COMMENT #111

Cable Assembly

Differential to Common Mode Conversion Loss
Limit

Bruce Champion, TE

Skew Impact on S_{dd21} & S_{cd21}

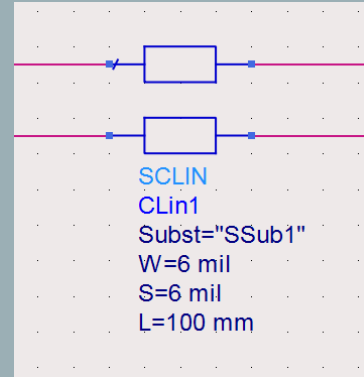
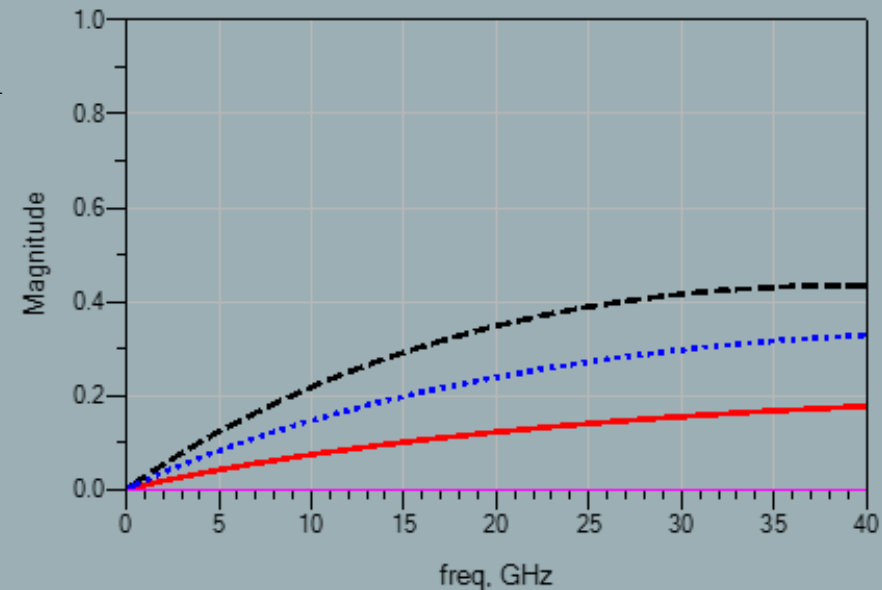
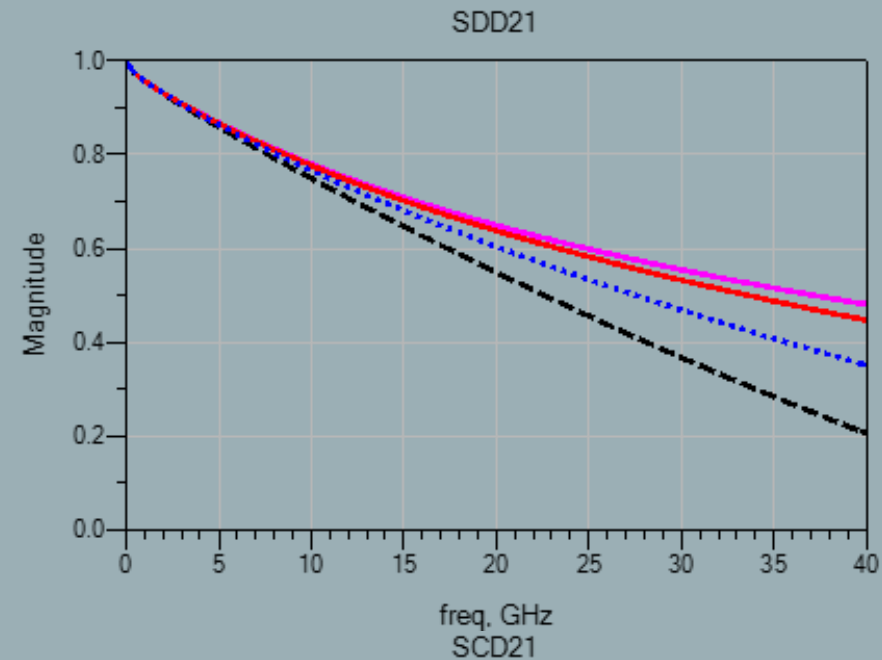
- S_{dd21} is modified by cosine/ S_{cd21} is modified by sine
- Higher frequencies impacted more than lower frequencies as skew increases
- If we subtract S_{dd21} from S_{cd21} to account for conductive and dielectric losses, $\Delta\theta$ is driving the change
 - Skew is driving change in $SCD21 - SDD21$
 - Limit line should be based on skew

Proposed Limit

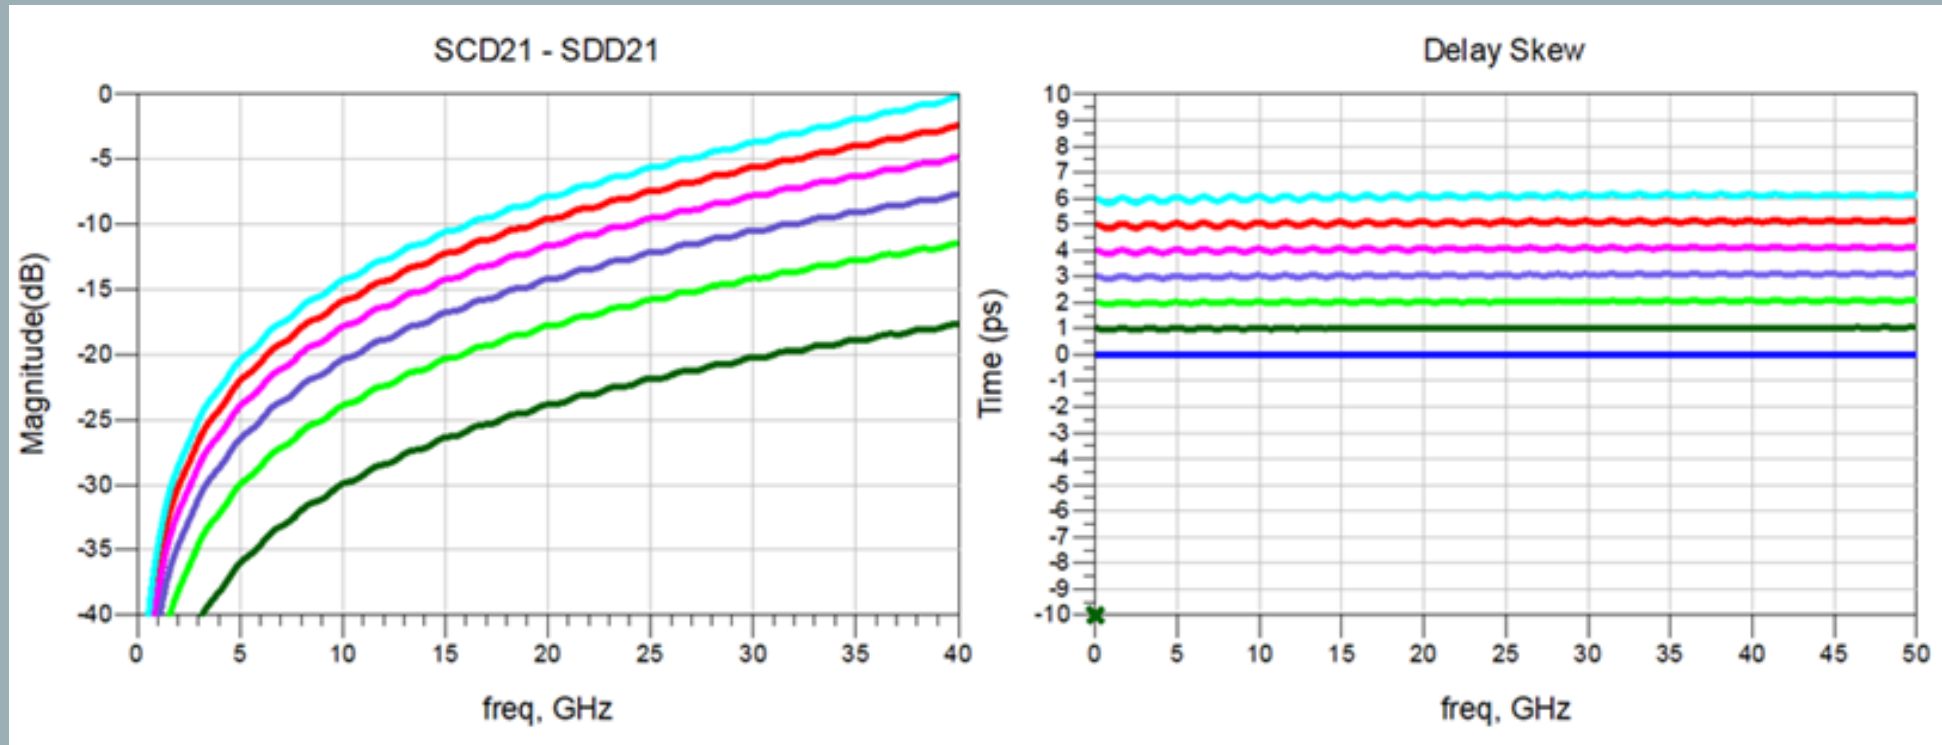
- We can calculate time skew (Delay Skew) as a function of frequency as shown below
- Plots represent a stripline trace with varying levels of time delay added to one leg
 - As time skew is increased, mode conversion is also increased
 - The Delay Skew plot is very flat in these images because this type of skew manifests itself as a “Frequency-independent” type of skew.

Proposed Limit

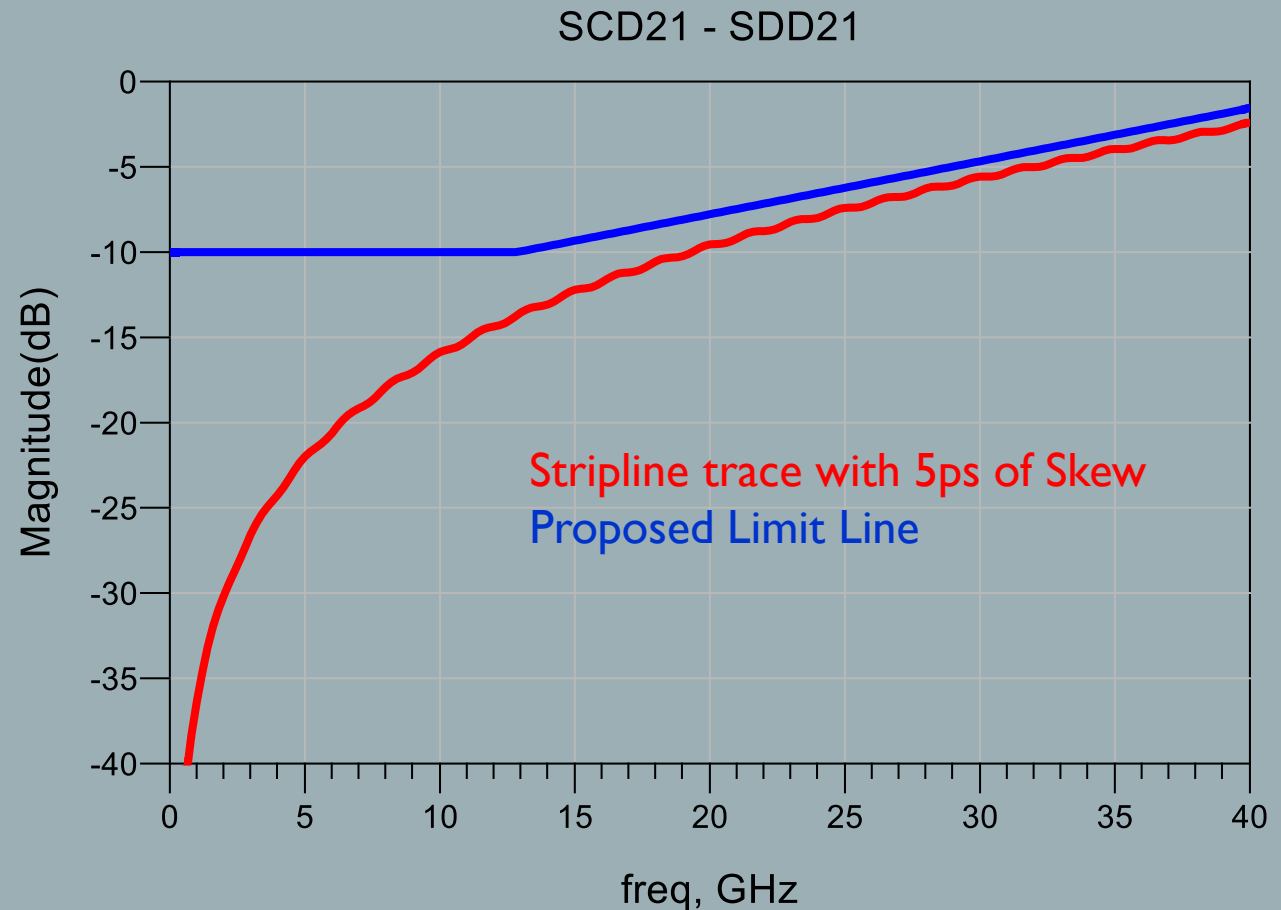
- A limit line based on skew is proposed
- Limit line is based on 5 ps of skew
- 5 ps allows for skew in cable assembly along with skew in MCBs
- Limit line:

$$S_{CD21}(f) - S_{DD21}(f) \geq \begin{cases} 10 & \text{for } 0.05 \leq f < 12.89 \\ 14 - 0.3108 * f & \text{for } 12.89 \leq f \leq 40 \end{cases}$$

- f is frequency in GHz
- $S_{CD21}(f)$ is the cable assembly differential to common-mode conversion loss
- $S_{DD21}(f)$ is the cable assembly differential insertion loss

Proposed Limit

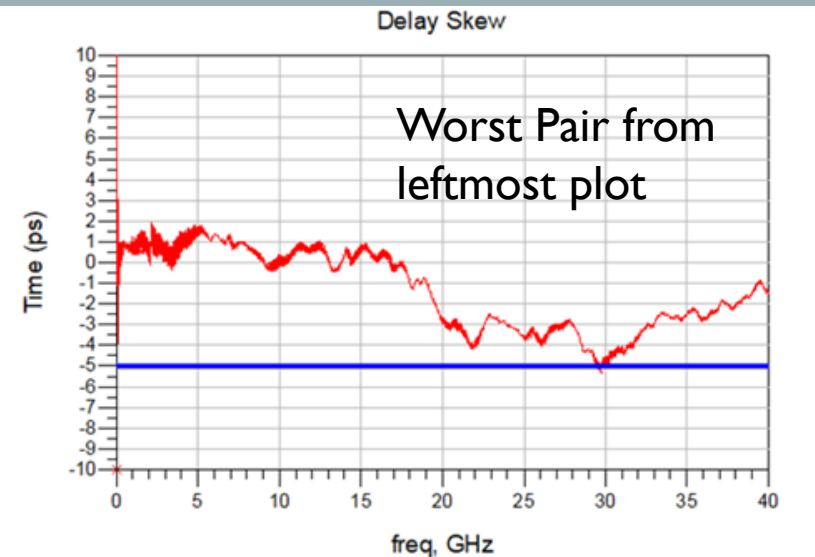
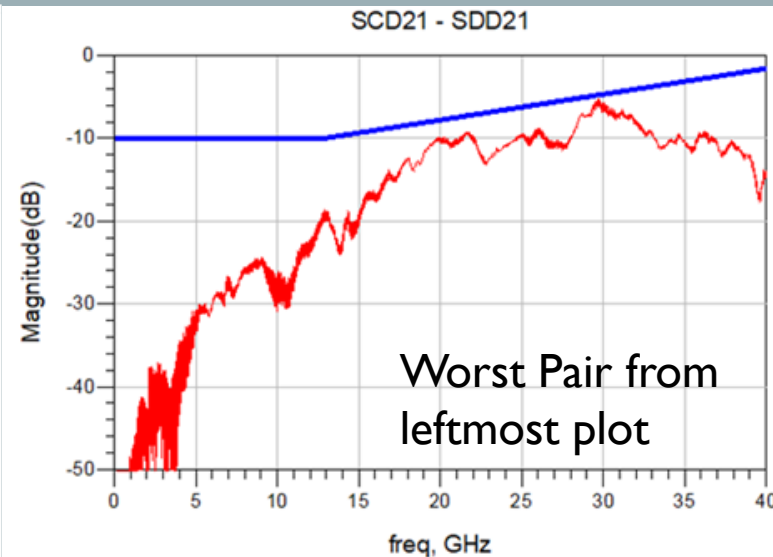
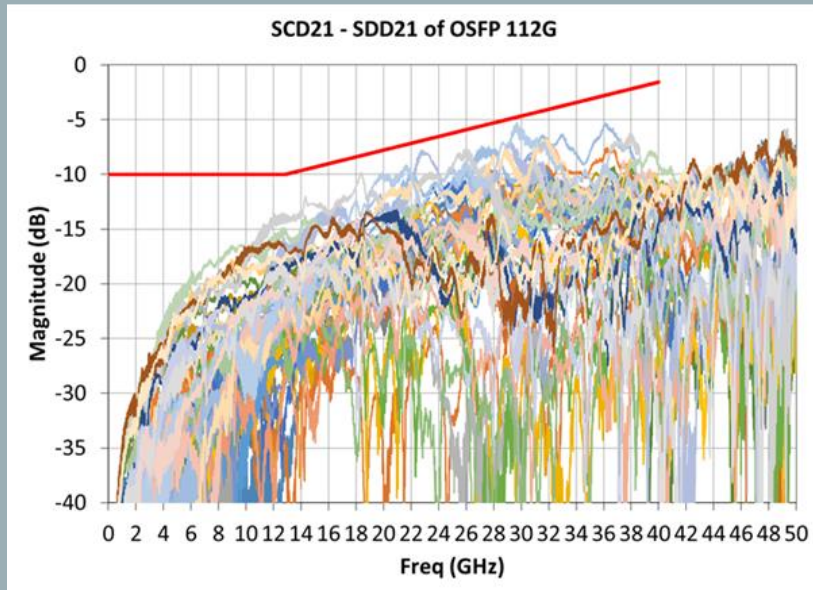
- Various cable assemblies have been measured against this limit and it a reasonable limit to pass in production
- These assemblies have also been distributed to various silicon vendors generating good BER
- BER vs skew as %UI does not seem to be intuitive (Have not seen a direct correlation)
- Word of caution
 - Not all skew is created equal
 - Skew on previous slides is frequency-independent (No change in Delay Skew across frequency)
 - Cables assemblies typically have frequency-dependent skew response (Cable & Design dependent)
 - Some have better skew at lower frequencies
 - Some have better skew at higher frequencies
